To	Goodman	From	Nina Barich
Copy		Reference	2227
Date	22 March 2023	Pages (including this page)	15
Subject	Clayton Business Park Flood Modelling

To	Goodman	From	Nina Barich
Copy		Reference	2227
Date	6 March 2024	Pages (including this page)	2
Subject	Response to Clayton Business Park Melbourne Water RFI - Stormwater

A Request for Further Information (RFI) has been received from Melbourne Water in relation to the redevelopment of Clayton Business Park, including some items relating to stormwater management. The following is the response to the stormwater RFI items.

Figure 3 – Existing 1% AEP Flood Depth

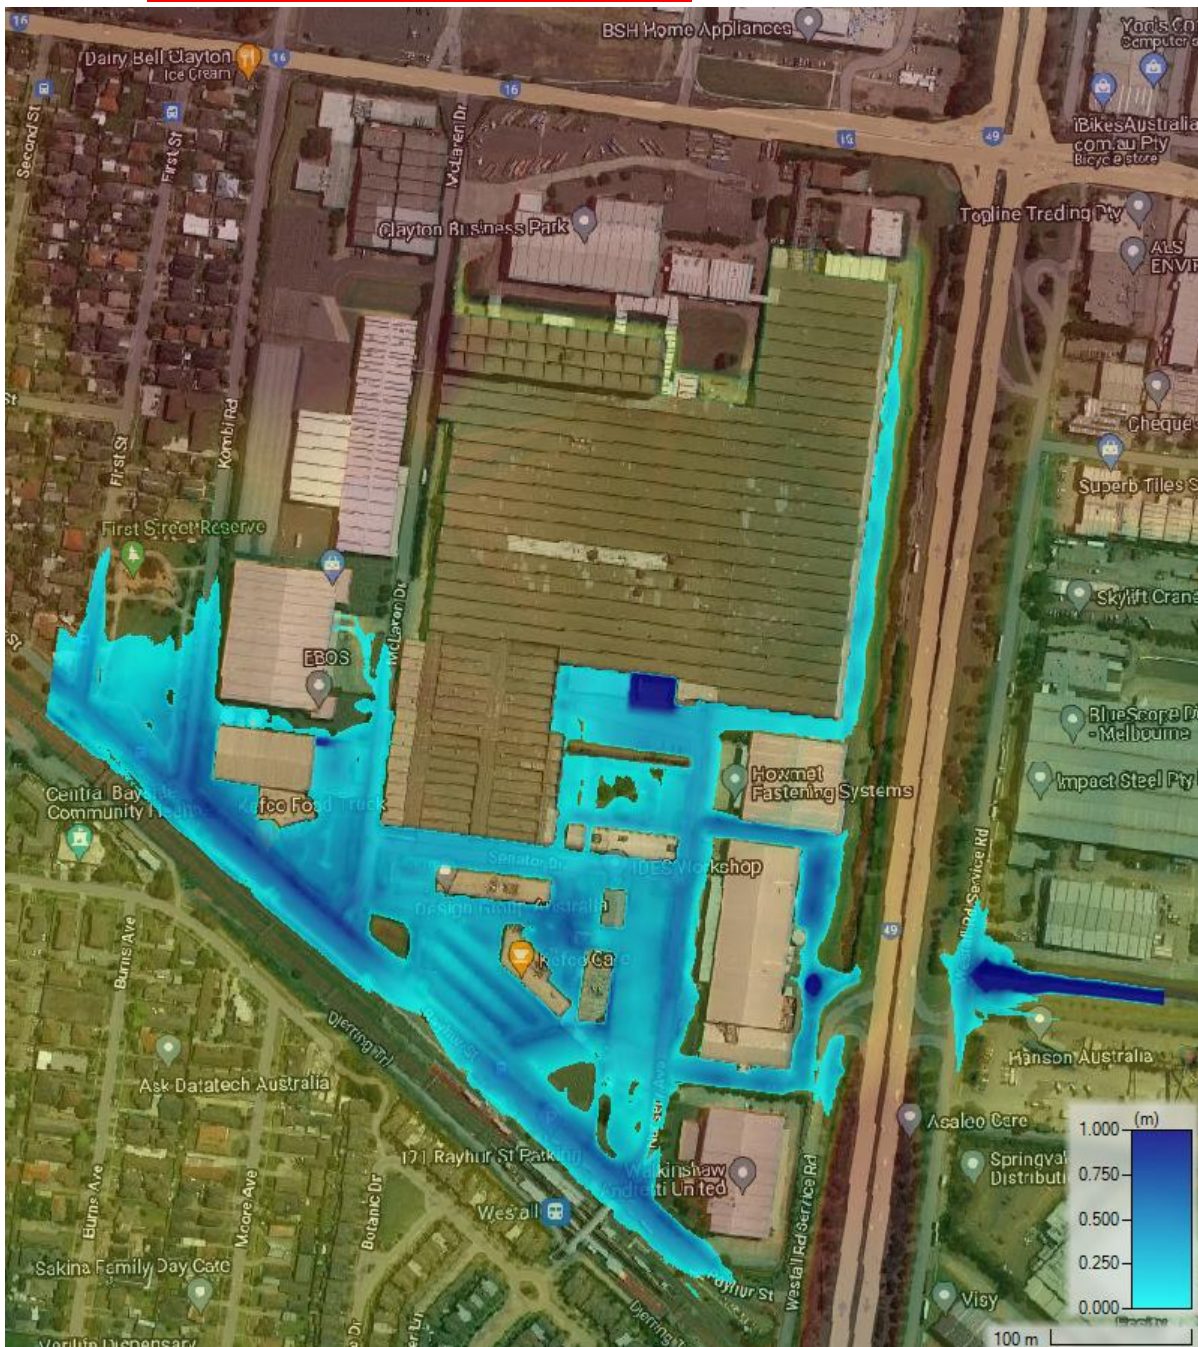
- *Model results, such as those depicted in Figures 3 and 4, need to be accurately labelled and presented in the report for clarity.*

The redevelopment and proposed mitigation measures will be remodelled in Tuflow, with an expected completion around mid-April. The modelling will be supported by a revised report which will address the issues stated above in relation to the boundaries applied, the coupling with the pipe network, the building blocks and mannings value applied and the peak flow used in the model and updated in a revised report. It is anticipated that this will be completed mid-April.
